PARK CITY MUNICIPAL CORPORATION PLANNING COMMISSION

July 27, 2016

Subject: 100 Daly Avenue
Project #: PL-16-03185
Author: Ashley Scarff, Planning Technician
Date: July 27, 2016
Type of Item: Administrative – Steep Slope Conditional Use Permit

Subject: Alice Claim Subdivision & Plat Amendment
CUP for Retaining Walls greater than six feet (6')
Ridge Avenue Plat Amendment
Project #: PL-08-00371, PL-15-02669, and PL-16-03069
Author: Francisco Astorga, AICP, Senior Planner
Date: 27 July 2016
Types of Item: Legislative – Subdivision & Plat Amendment
Administrative – Conditional Use Permit

SITE PLAN
SCALE 1/4"=1'-0"

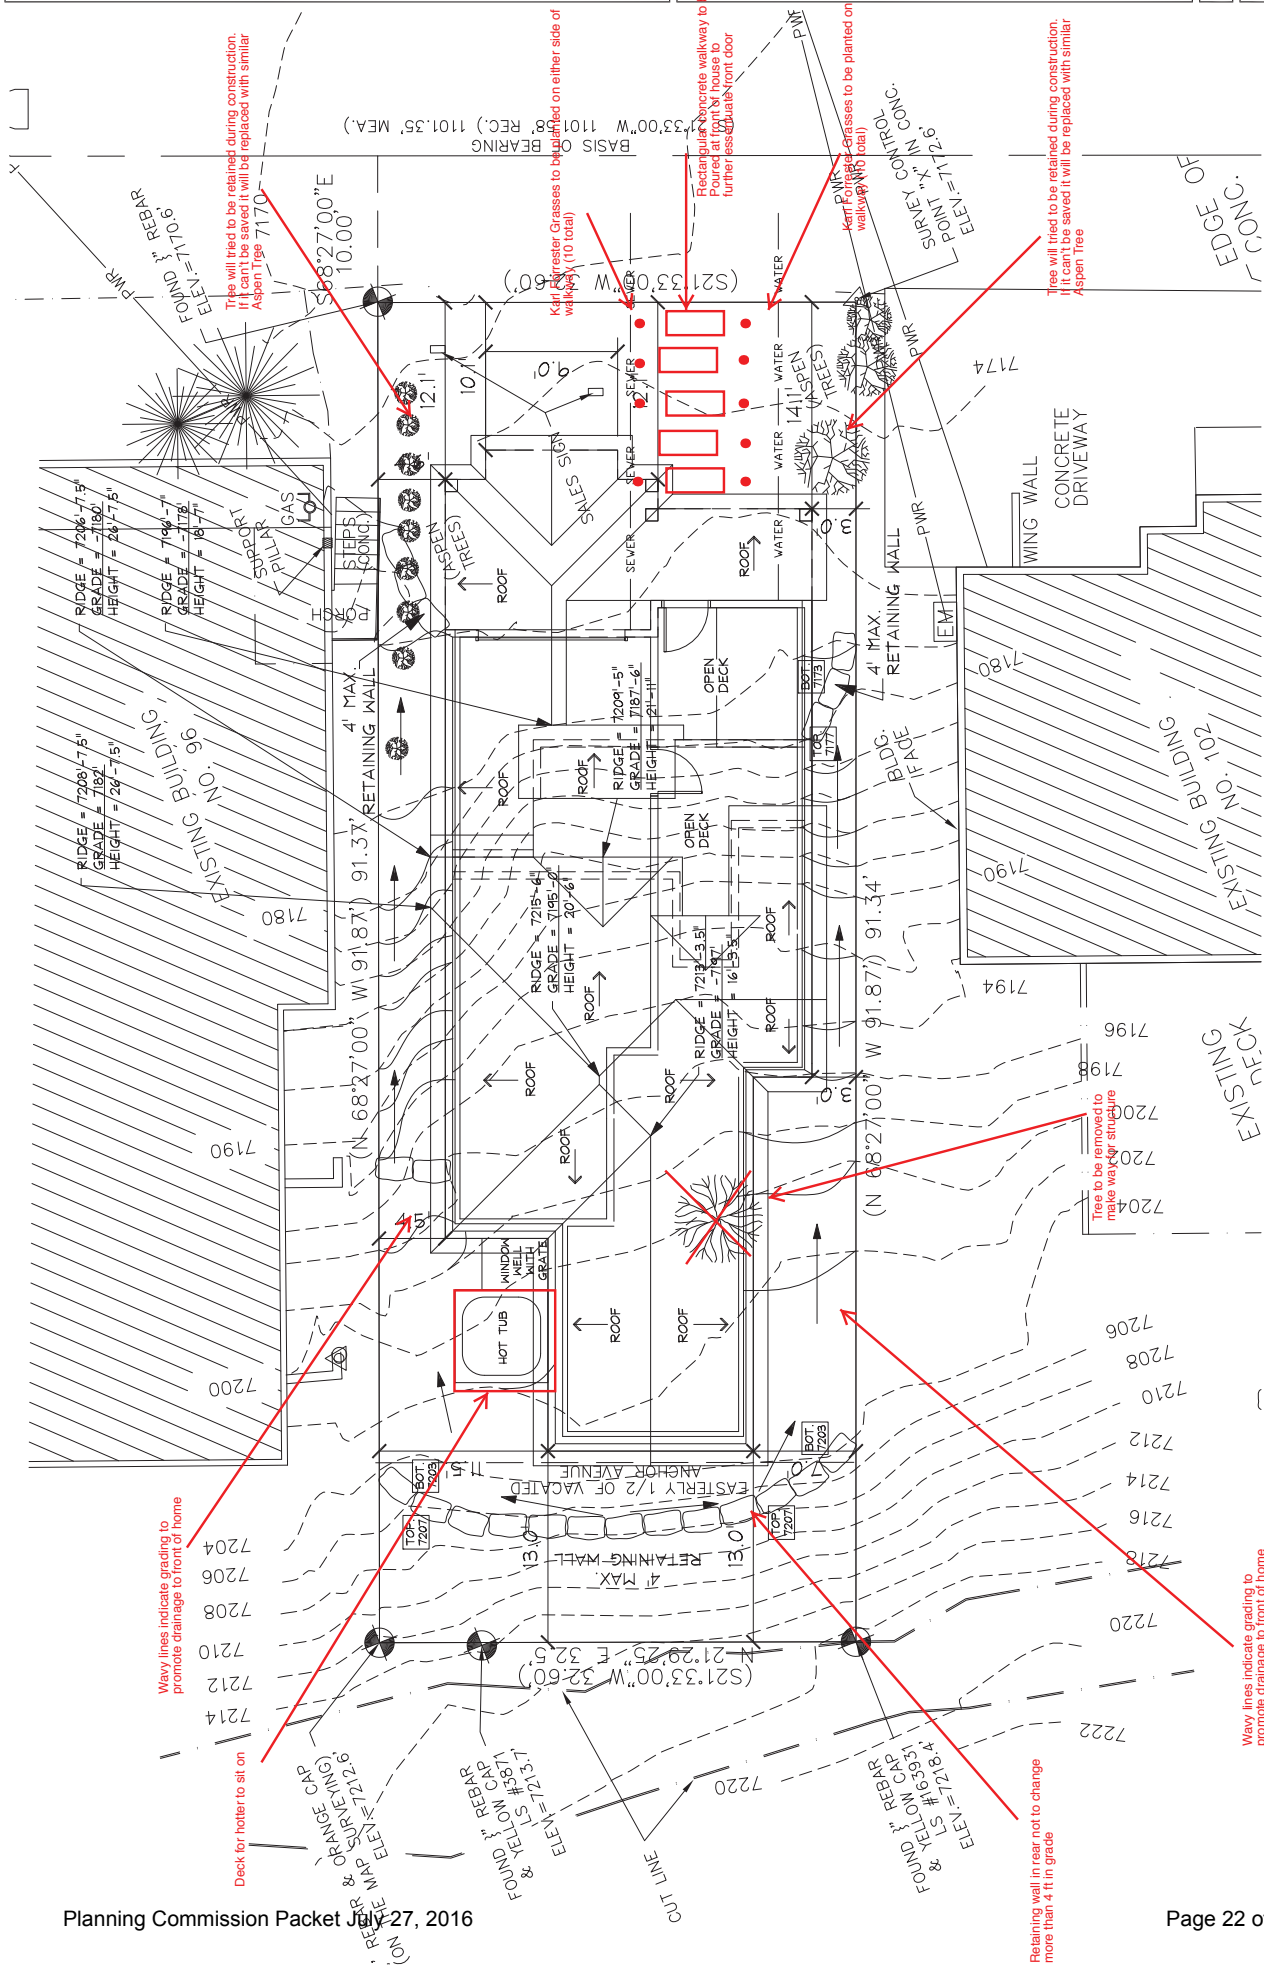
The site design and reduced building footprint provide an increased northern side yard setback area. The remaining setback areas are consistent with the pattern of development and separation of structures in the neighborhood. The proposed driveway is twelve feet (12') in width, which is the maximum desired driveway width, as outlined in the Historic District Design Guidelines. Last, the landscape plan shows that at least two (2) existing aspen trees near the north and southeast corners of the lot will remain in place if feasible, with the remaining seven (7) affected significant trees replaced in-kind following construction.

LEFT ELEVATION
SCALE: 1/4" = 1'-0"

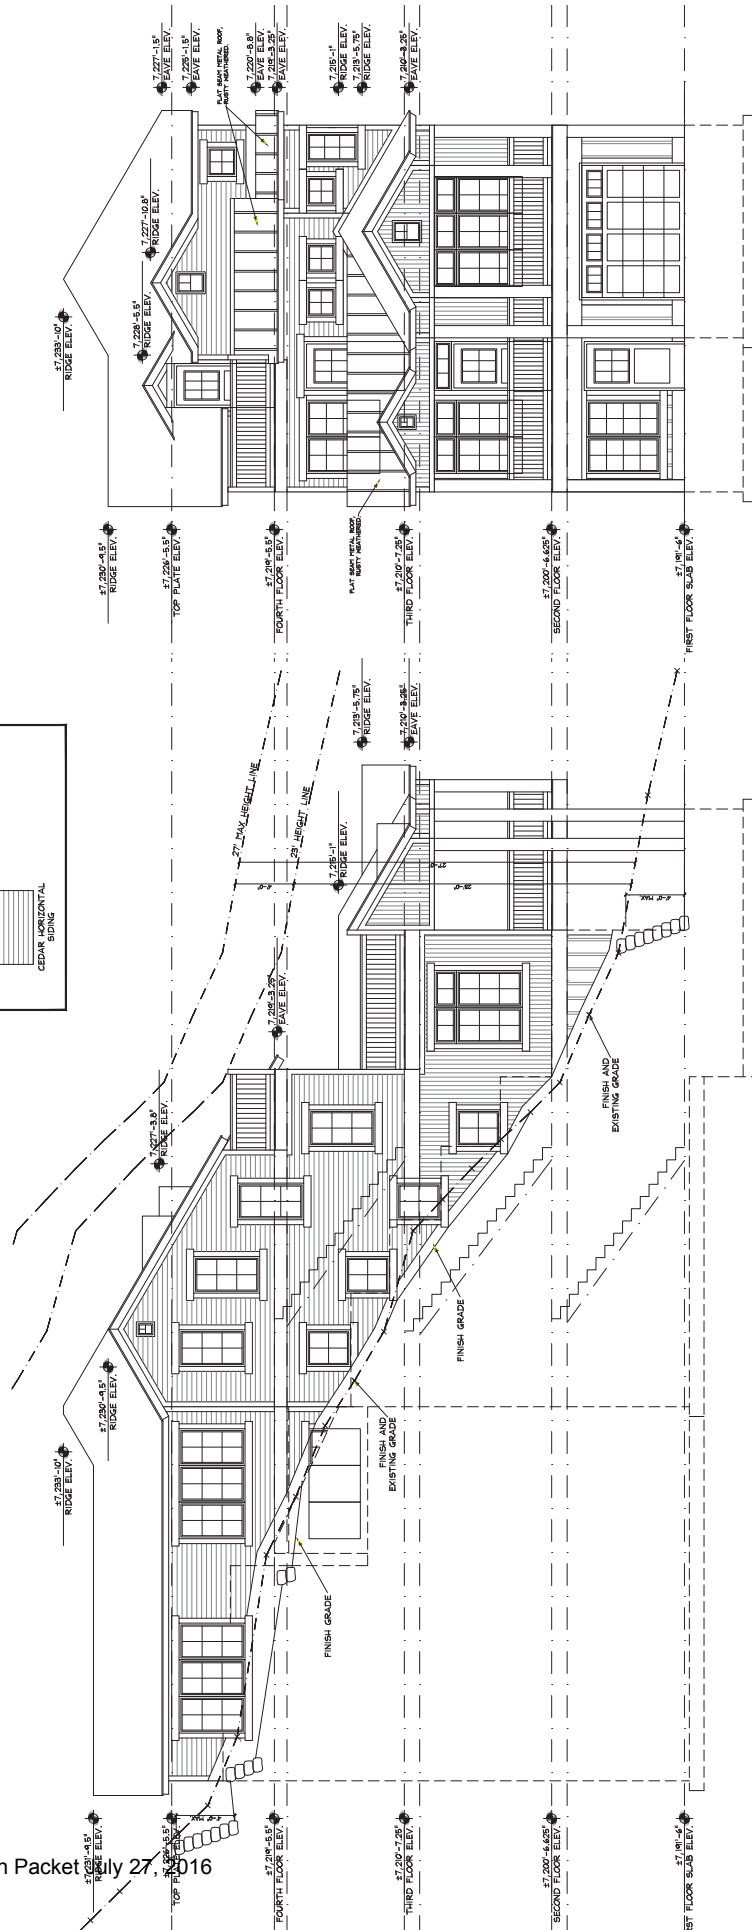
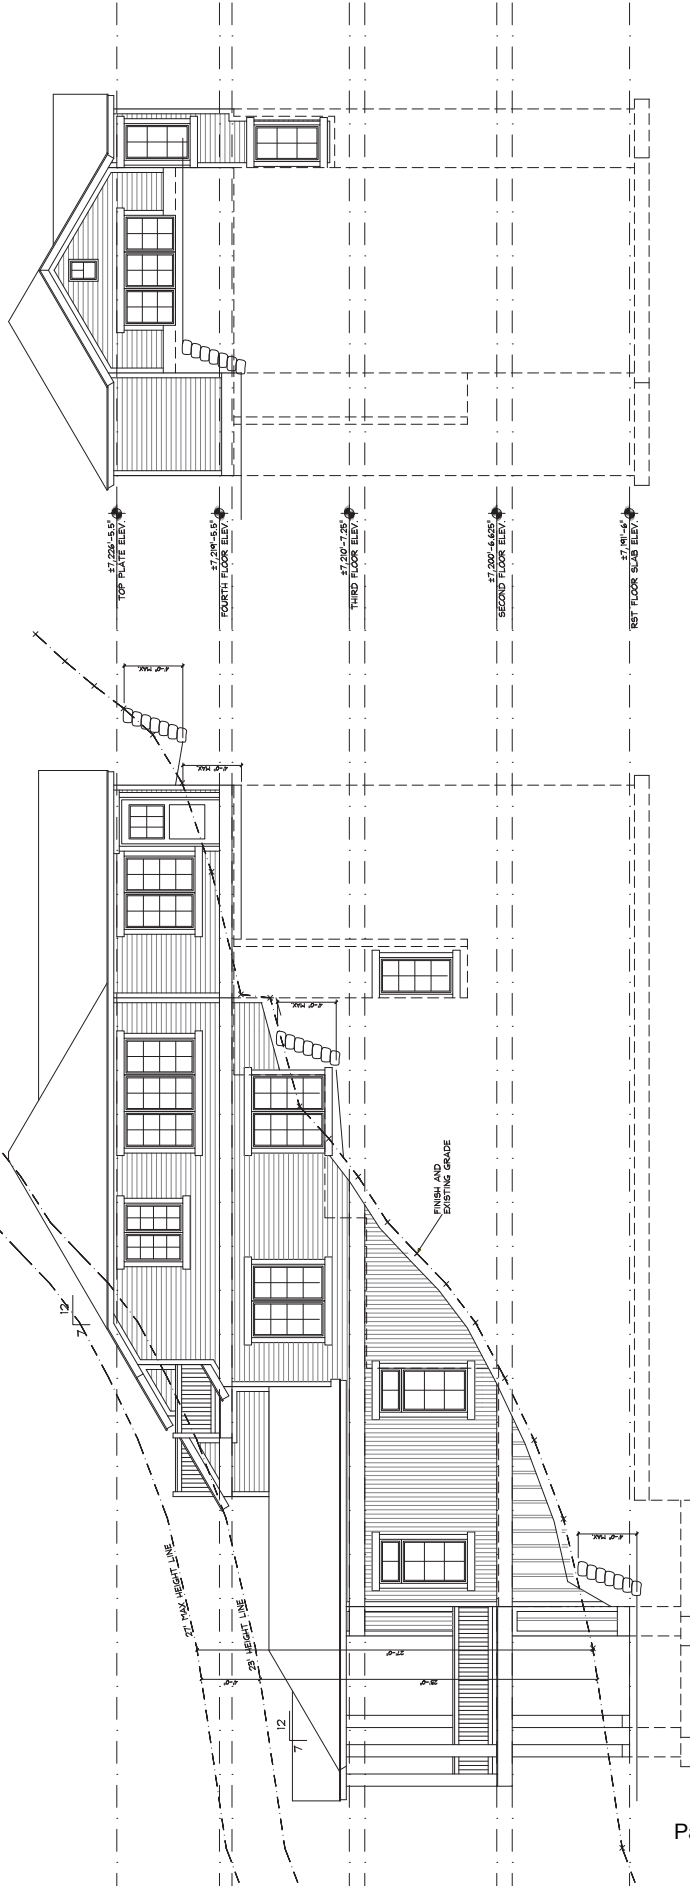
As outlined above, the structure as shown in the current plans has an approximate 9 ½ foot (9.5') vertical step in the downhill façade, which is 6 inches (6") short of the LMC requirement of a 10 foot (10') vertical step in the downhill façade. Staff has conditioned the approval of this steep slope CUP to ensure that revised plans are in compliance with the vertical articulation requirement of the LMC.
